1.4 2011 VBWD Plan Amendment

In 2011 this Plan was amended to document the inclusion of two new subwatersheds that were formerly part of the Lower St. Croix Watershed Management Organization (LSCWMO): Kelle's Coulee and Swede Hill Creek. The Kelle's Coulee watershed is a 3.7 square mile watershed located along the former southern boundary of the VBWD. The Swede Hill Creek watershed is approximately 1.3 square miles in size and located adjacent to the Kelle's Coulee watershed and St. Croix River. The 5 square miles added by the additional watersheds increases the total VBWD area to 70 square miles.

Figure 2-1

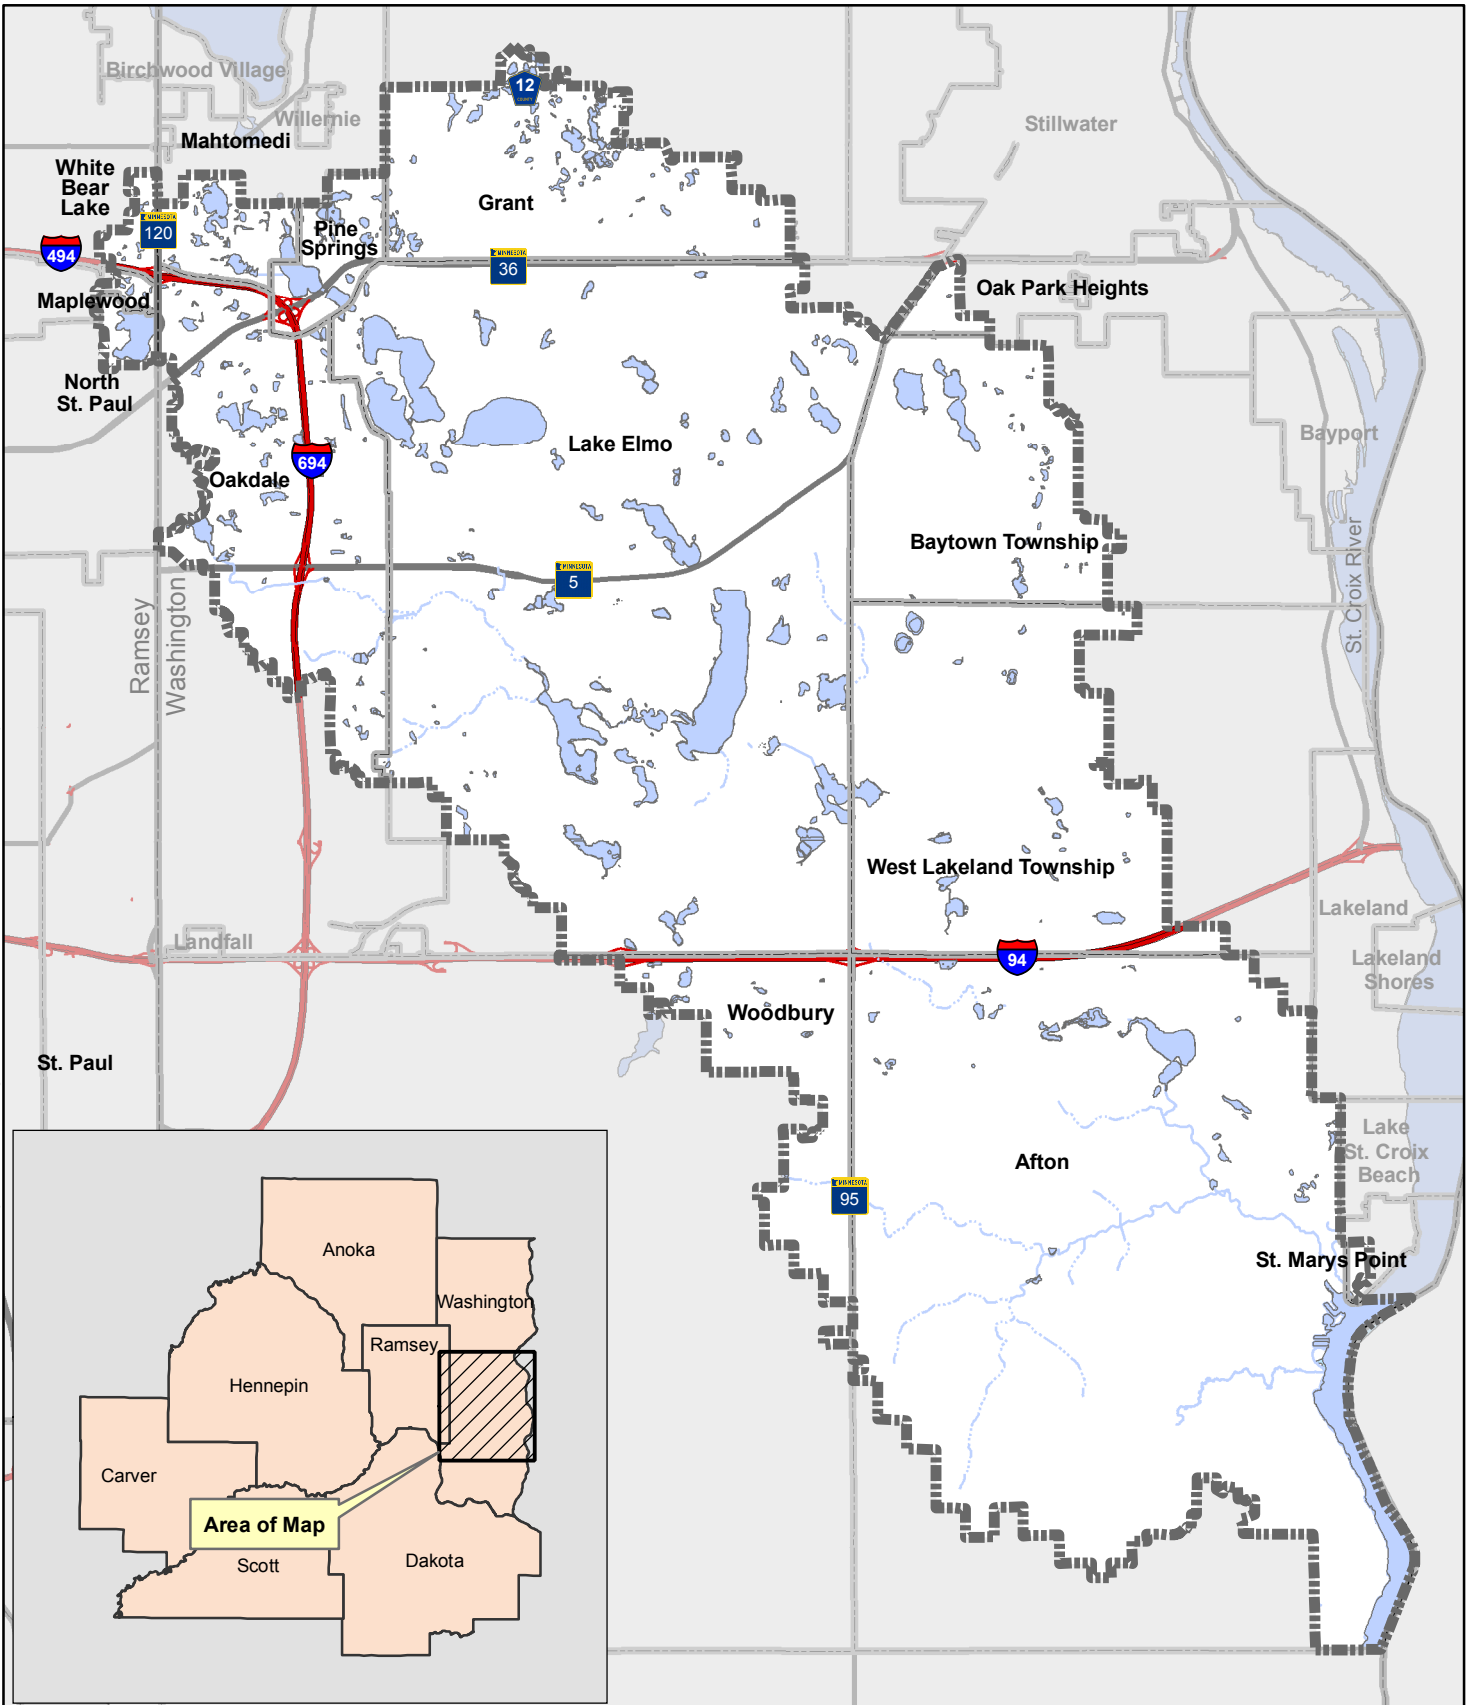
- Revised jurisdictional boundary in Figures 2-1 and 3-1
- Revised watershed boundaries in Figure 3-2
- Updates to Section 4 – Overall Issues, Goals and Policies, including:
 - Section 4.3 – Stream Management and Restoration
 - Section 4.4 – Stormwater Management
 - Section 4.6 – Groundwater Management
- Additional individual watershed management plans, including
 - Kelle's Coulee (Section 5.37)
 - Swede Hill Creek (Section 5.38)
- Revised Implementation Tables (Tables 7-1 and 7-2)
